Subject: Catawba Nuclear Station, Units 1 and 2
Docket Nos. 50-413 and 50-414
Reply to Notice of Violation
Inspection Report Nos. 50-413/94-17 and 50-414/94-17

**DUKE POWER COMPANY
CATAWBA NUCLEAR STATION
REPLY TO NOTICE OF VIOLATION
50-413, 414/94-17-02**

FIGURE 1. POST-ACCIDENT INSTRUMENT ACCURACY PROFILE FOR SNSWP
TEMPERATURE

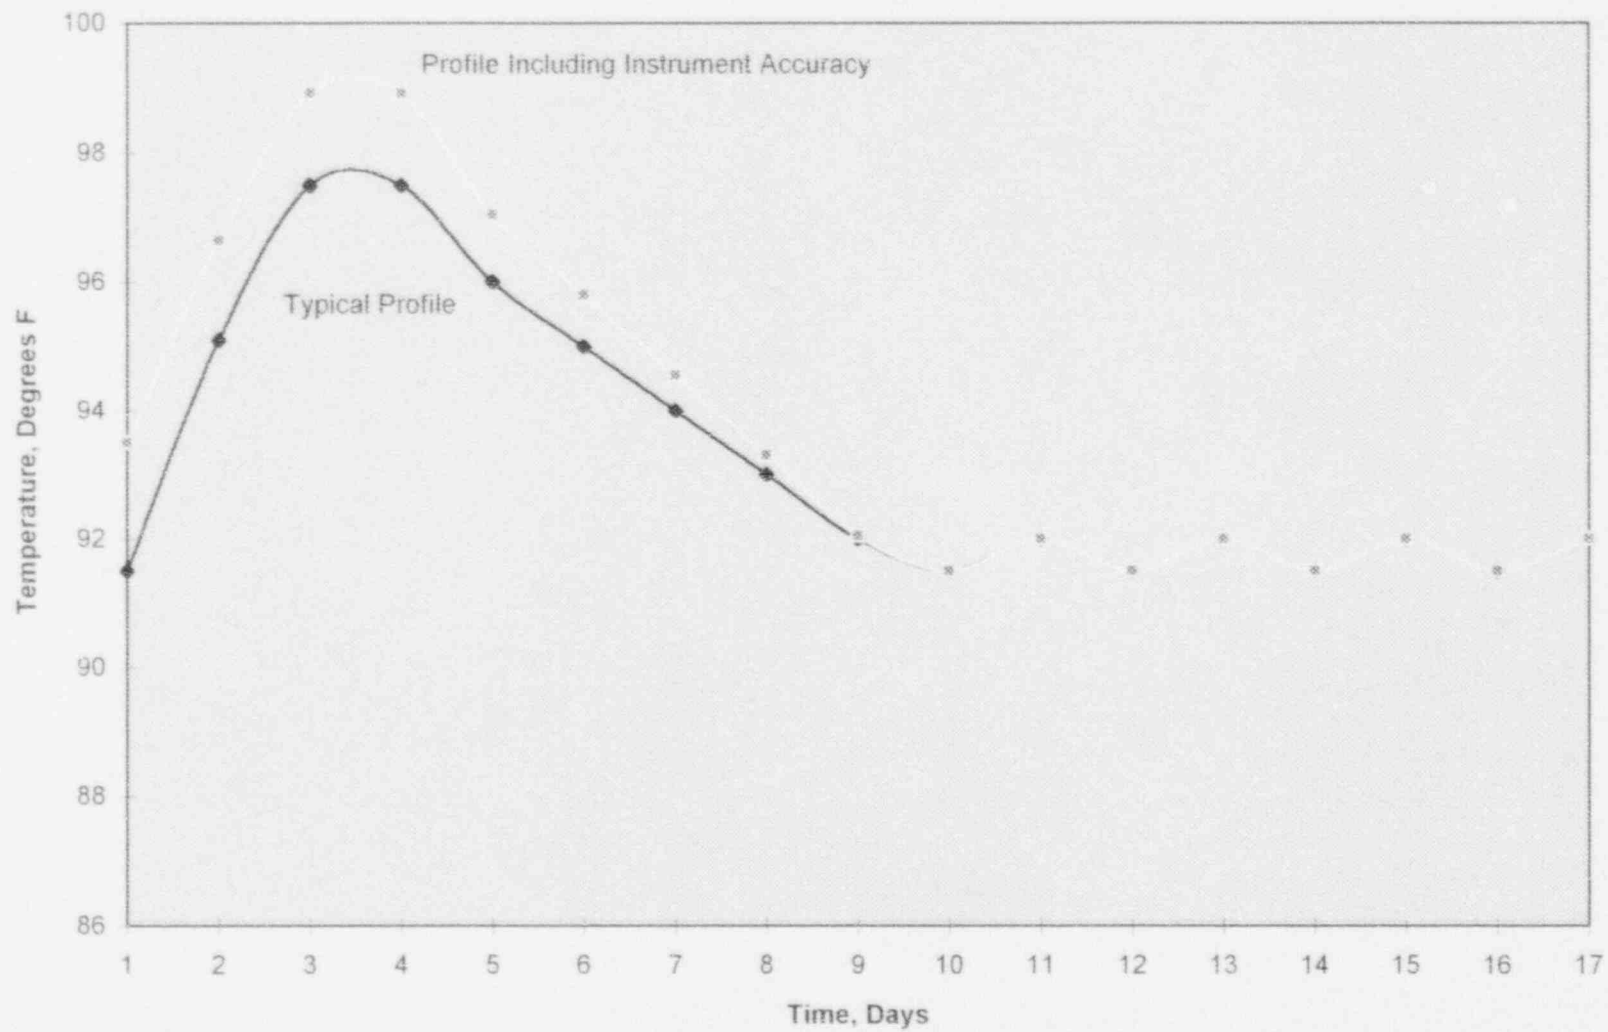
Standby Nuclear Service Water Pond level and temperature are inputs into the analysis which determines the post-accident temperature of the SNSWP. Post-accident SNSWP temperature is an input for the following analysis:

1. The containment accident analysis (i.e., peak accident pressure). The effects of SNSWP temperature and level instrument inaccuracy on the containment analysis have been reviewed and determined to be of no safety significance. This is based on the

considerable margin present in the containment design. The following is a summary of the available margins and conservatism in the containment analysis:
